GRAND VALLEY
STATE UNIVERSITY

College of Liberal Arts and Sciences
Geology Department

July 9, 2019

We have been following closely the sediment sampling plan for the Grand River proposed by Grand River Waterway in DEQ Permit # WRP014388. We have several concerns with the proposed sampling plan, the proposed sampling methods, and the data on which the plan was based. Dr. Peter Wampler (Grand Valley State University) has been working with students studying and mapping the Grand river since 2013 and Dr. Kory Konsoer (Louisiana State University) has extensive river surveying expertise and has been collaborating to collect bathymetry and hydraulic data on the Grand River between Fulton Street and the Bass River since 2016.

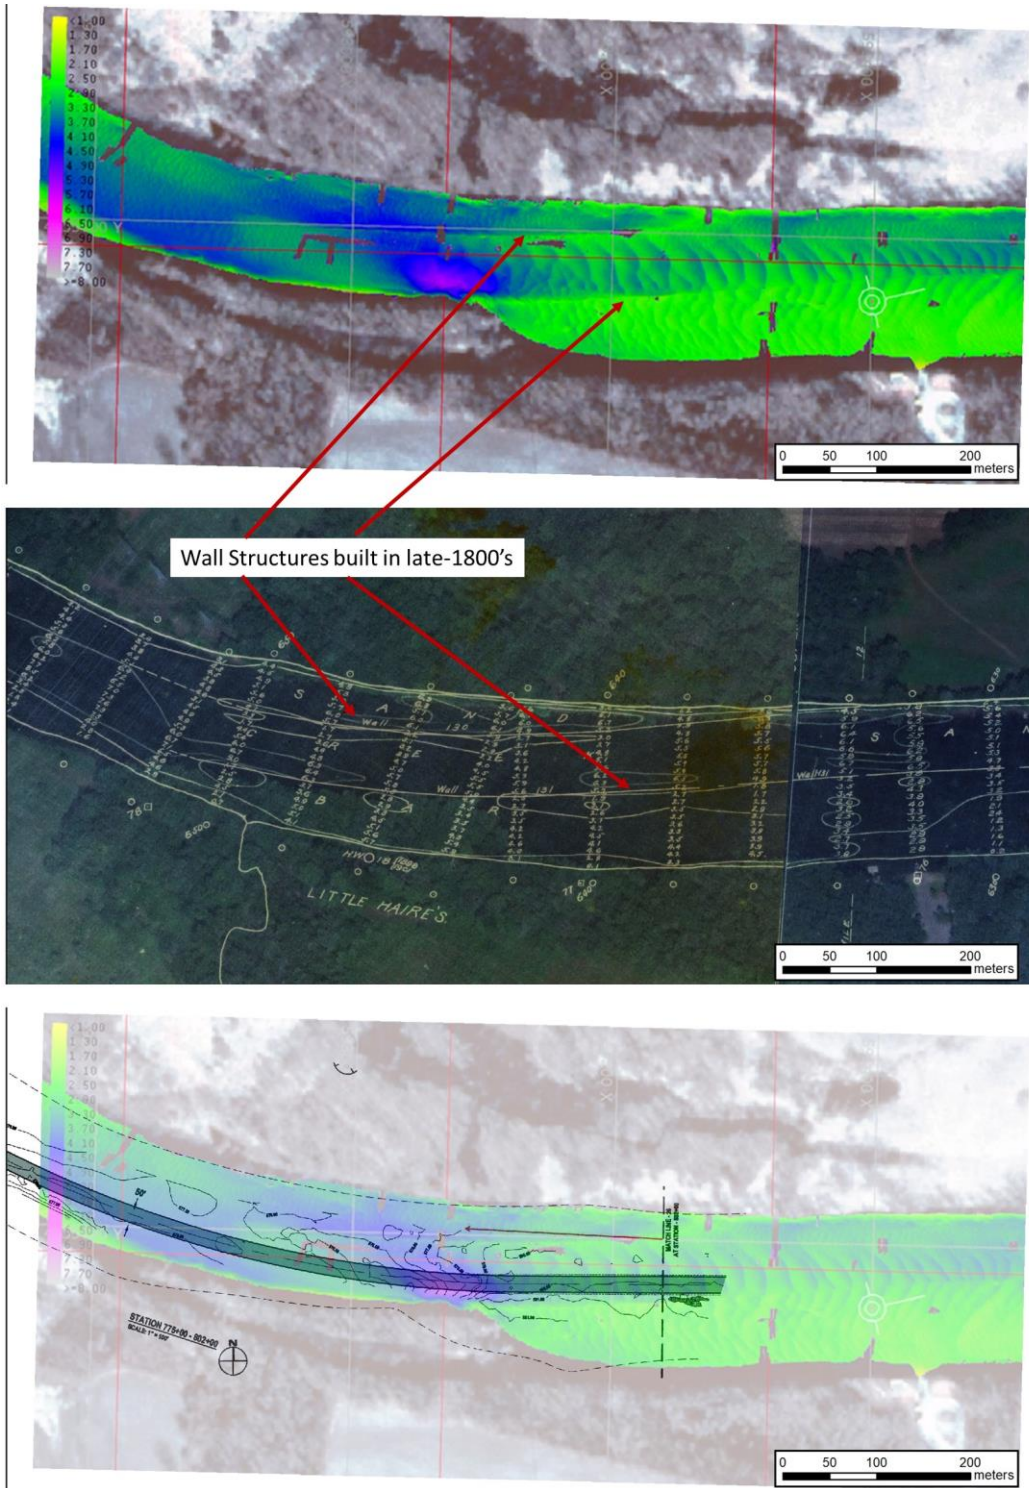
To demonstrate the level of detail obtained by the MBES survey, we have included preliminary images of the bathymetric data gridded at 0.5 meter for a reach of the river near the Grand River Park Boat Launch in Georgetown Township, Michigan (Figure 1). These images clearly show the wall structures and their effect on the sediment bedforms in the channel, as well as their relationship to the channel islands. We also include an image showing the same area from the 1906 survey maps for comparison. The dredging bathymetry study and a selected panel from the proposed dredging plan are also provided for comparison.

1. The 2017 bathymetry survey performed by Edgewater Resources provided a limited view of the shape and morphology of the river. Significant areas near the edges of the river were not surveyed. The focus was on areas that would be dredged rather than providing a complete dataset for the bathymetry of the entire river. The Edgewater Resources study thereby misses portions of the channel that may be impacted by the dredging or have converted to upland due to sediment deposition and training wall structures installed in the late 1800's.

1. Prior to sediment sampling a full geomorphologic evaluation of sedimentation and erosion using the modern bathymetry and 1906 mapping should be completed.

Figure 2. Top) Historic photos of installation of wooden pilings used to train the Grand River in the late 1800's. Bottom) Dredging vessel Colonel Farquhar circa 1905 used on the Grand River in the late 1800's.

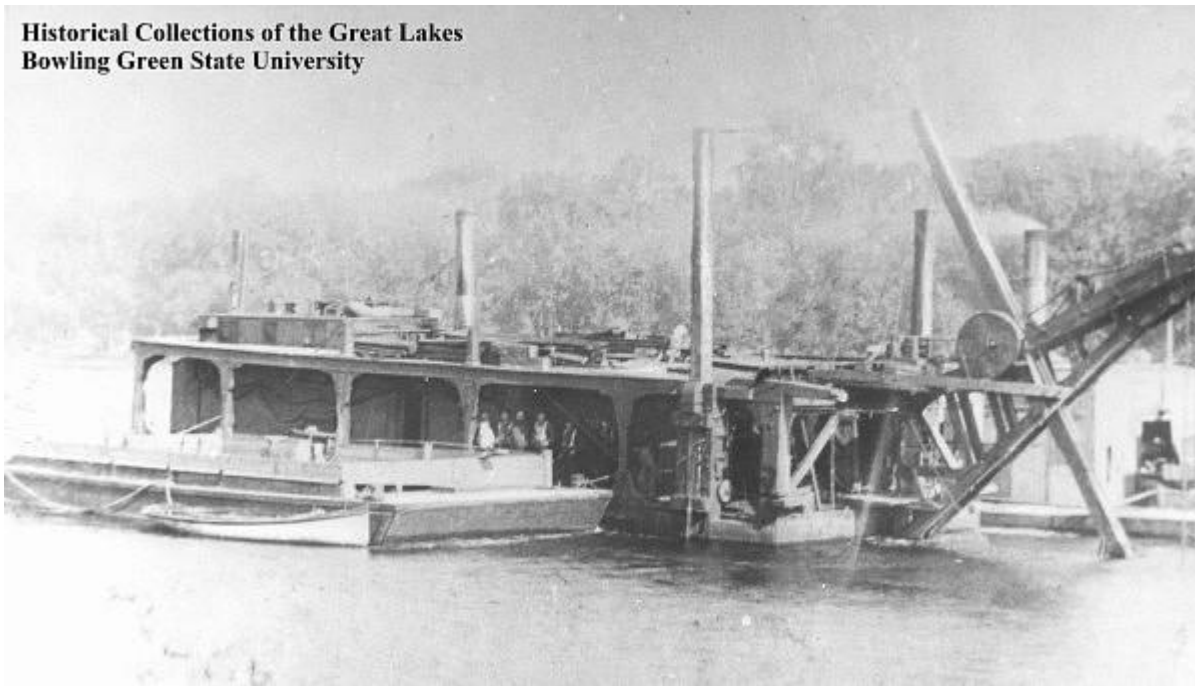
2. The dredging and sampling plan do not take into consideration the presence of late 1800's training walls depicted on the 1906 mapping (Figure 2). These walls are clearly controlling modern river velocities, bedforms, sedimentation, and erosion, and should be explicitly considered by any sampling or dredging plan. These walls are typically well preserved in the bed and banks of the river and may qualify as historic structures subject to State Historic Office preservation laws.
